Application Reference: BE/40/26/DOC Site Name: Chalcroft Nurseries Chalcroft Lane Bersted PO21 5TS	Initial Issue Date: 09/07/26 Issue Date: 09/07/26 Reviewer Reference: EXT/02
---	---

Summary and Recommendation:

HM Land Registry
Official copy of
title plan

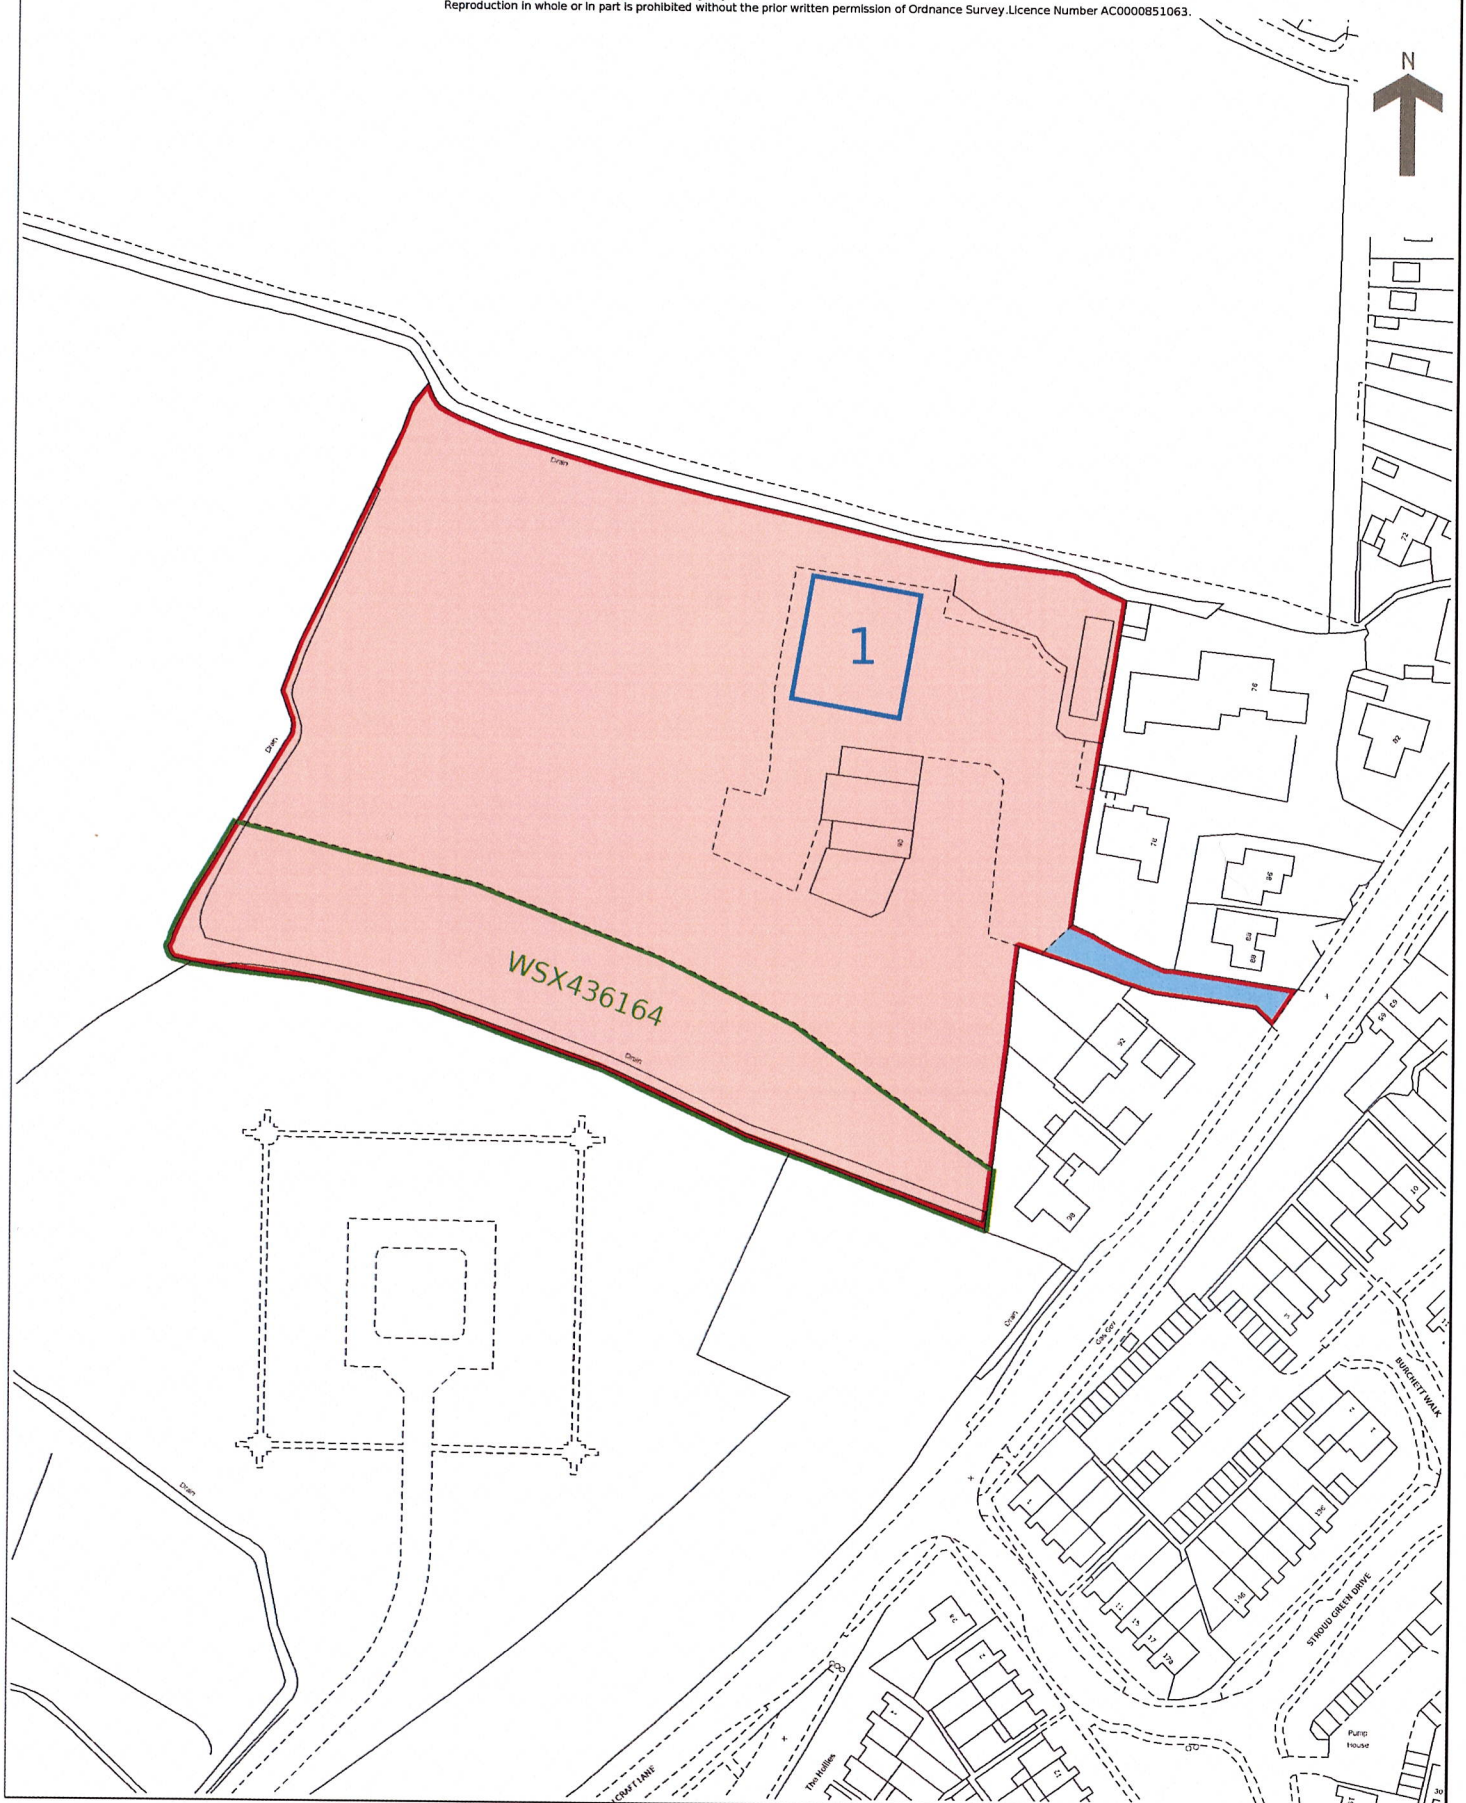
3.	The connection to the watercourse appears to be outside of the redline boundary. It should be demonstrated that the applicant has the right install the proposed drainage in land outside of their control (NSfS Standard 1 - Runoff destination)	The site owner is the riparian owner of the ditch at the north of site; there is no third party land. Title Plan is attached to this response.

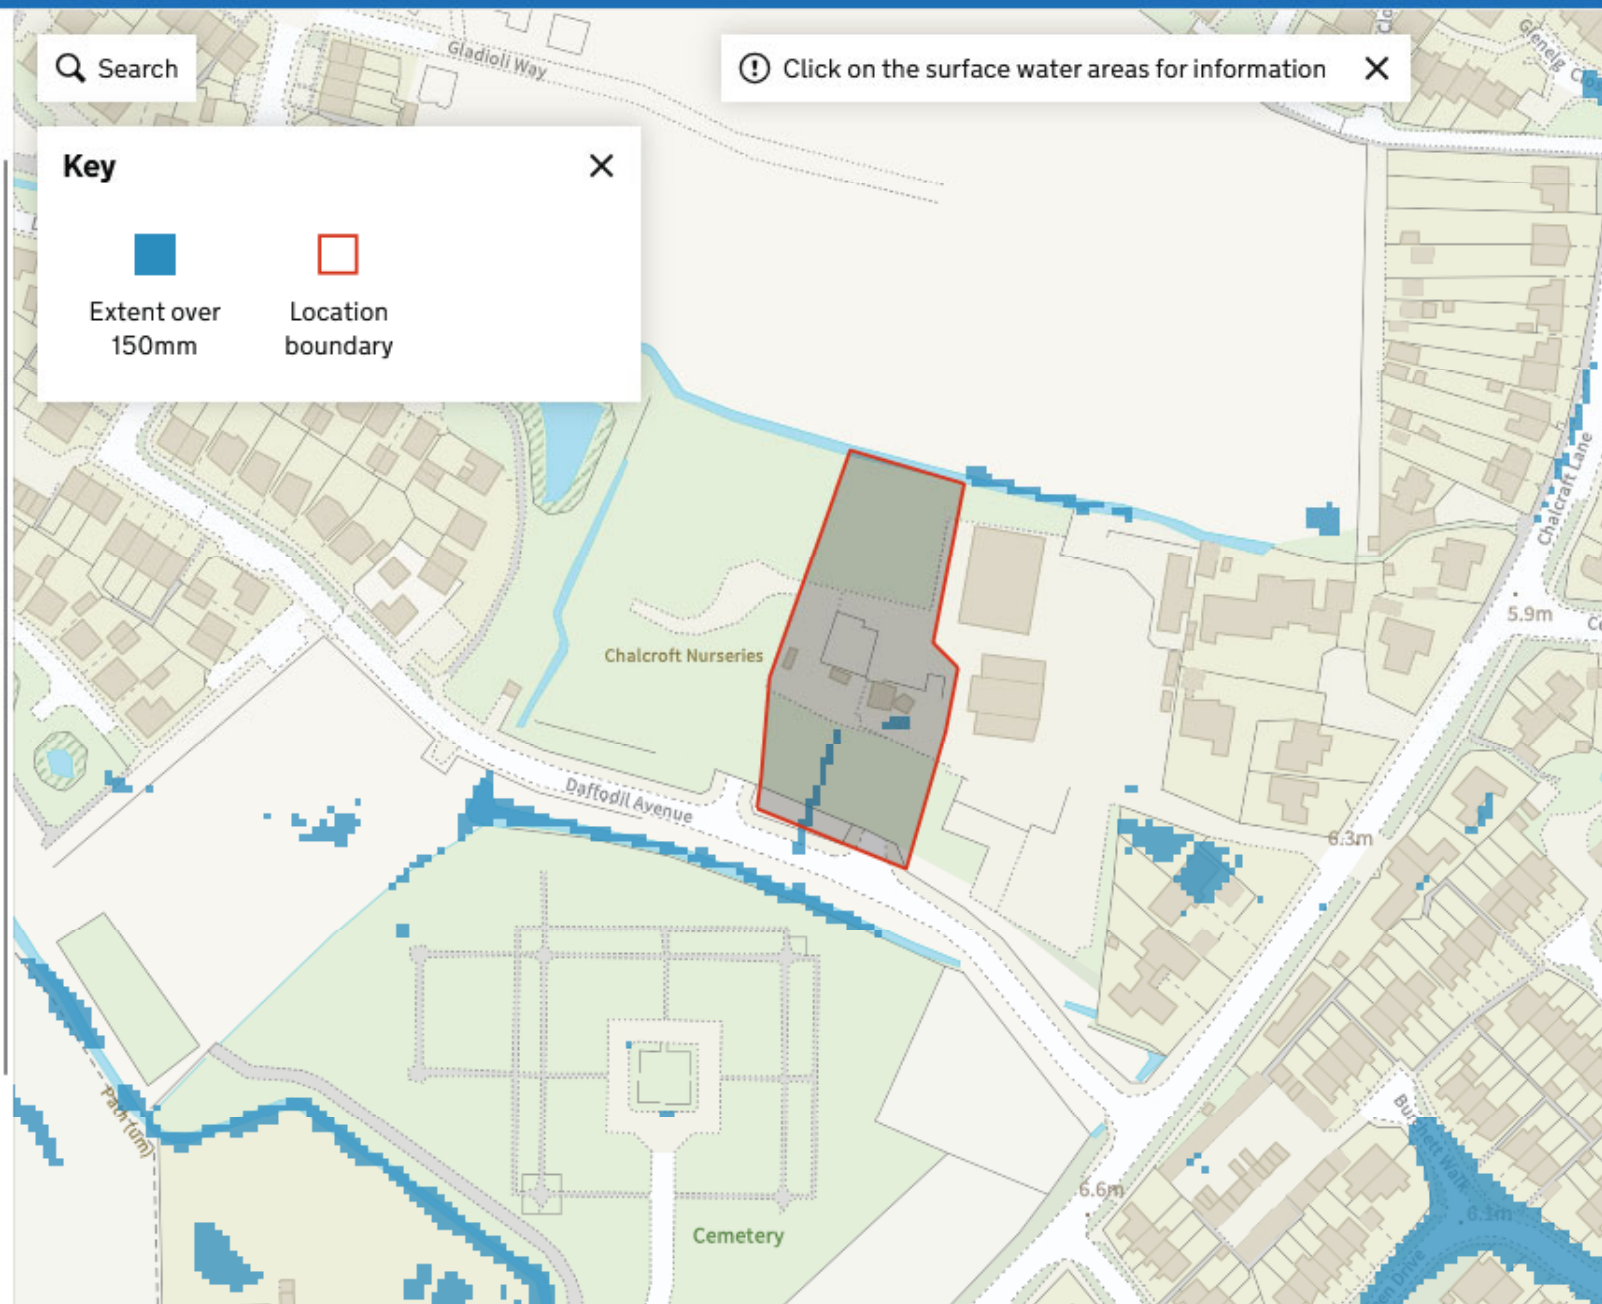
7.	It has not been demonstrated that surface water flow from elsewhere will be safely conveyed around or through the site without compromising the SuDS system. It is noted from the Flood Maps for Planning that some surface water flood risk is shown which could be an overland flow route from Daffodil	The Flood Risk Assessment was considered and approved as part of the outline planning application. There are no surface water flow paths crossing the site and the site has been designed to accommodate a 100 year rainfall event plus 45% for climate change and there will not be surface water ponding on the site post

Avenue. (NSfS Standard 3 – Extreme rainfall)	construction. Surface Water Flood Map attached. The surface water ponding noted adjacent to Daffodil Avenue and on the south of the site does not indicate a flow path through the site. Both Daffodil Avenue and the site will be new development with suitable surface water drainage schemes. Post construction there will be no surface water ponding in the locations indicated as both areas will be positively drained.
